**TOWN OF BAY HARBOR ISLANDS
PLANNING AND ZONING BOARD**

FINAL AGENDA

ITEM: Request for approval for an addition for “Brett and Maria Reizen” located at 9424 W. Broadview Drive, Lot 82-83 of Block 23. The owners are proposing an addition and renovation to an existing single family residence. The proposed two story home will approximately have 5,969 square feet of a/c living space with a two car garage. The residence will have (7) seven bedrooms, (7) seven bathrooms, (1) one half bath and a theater. Enclosed please find the site plan and elevations. (Item #1A)

**Town of Bay Harbor Islands
Planning and Zoning Board Staff Report
Additions and Renovations to an Existing Single-Family Residence
9424 West Broadview Drive
September 27th, 2017
Page 3**

CABANA EXTERIOR ELEVATIONS
SCALE: 1/4"=1'-0"

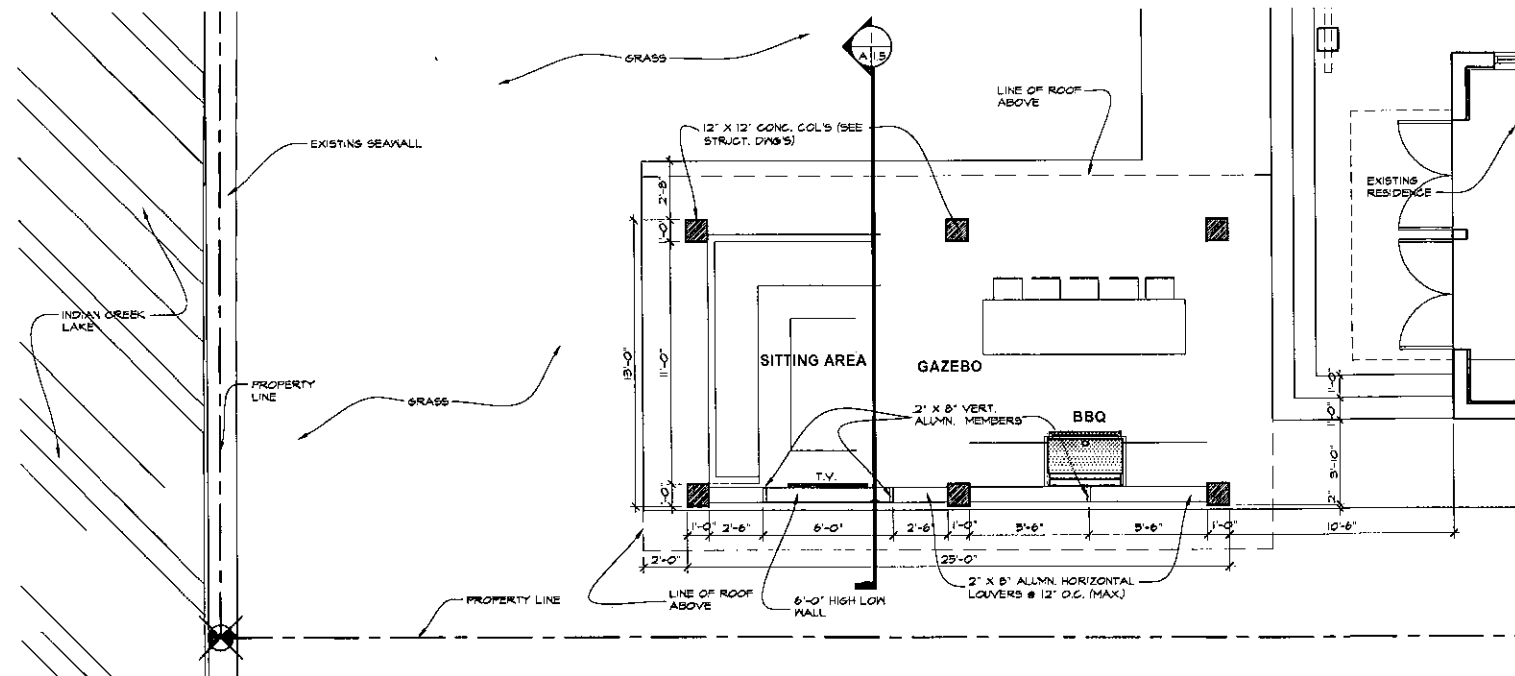
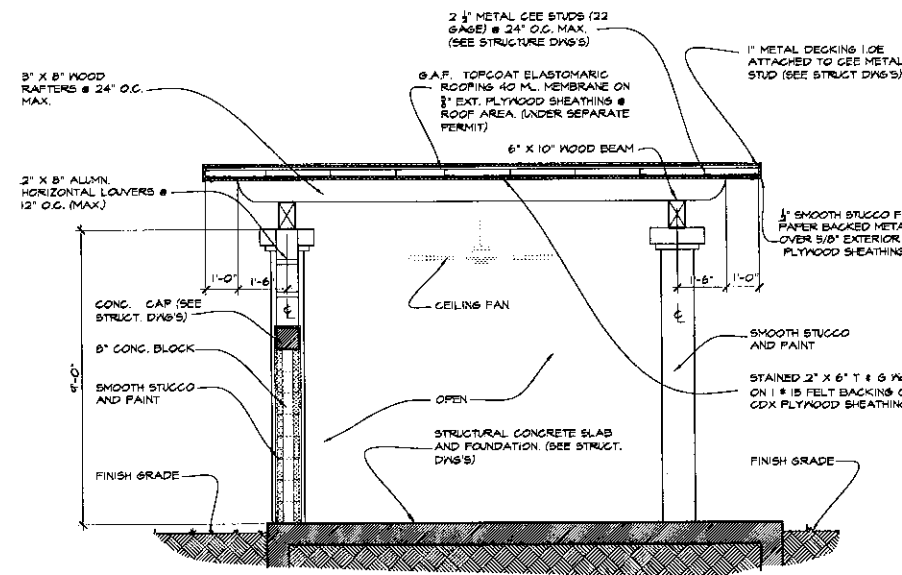
It should be noted that the proposed plans show a pool cabana structure in the rear of the property. Per Section 23-12(15)(e)(iii), certain open, airy and decorative structures such as pool cabanas may project into the rear and side yard setback areas (or into the front and side yard setback areas of waterfront lots) to a point no closer than five feet from the lot line or the seawall for waterfront lots, subject to written approval by the Planning and Zoning Board. The applicant is requesting Planning and Zoning Board approval for the cabana structure per Sec. 23-12(15)(e)(iii).

- 1) This approval is based on the plans prepared by Choeff Levy Fischman Architecture and Design dated submitted electronically to MMPA on September 22nd, 2017 with any modifications required by the PZ Board. All modifications to the above plans shall be reviewed by Town staff and may require re-approval by the PZB if felt to be substantial.
- 2) The PZ Board finds the pool cabana structure design / location is acceptable.
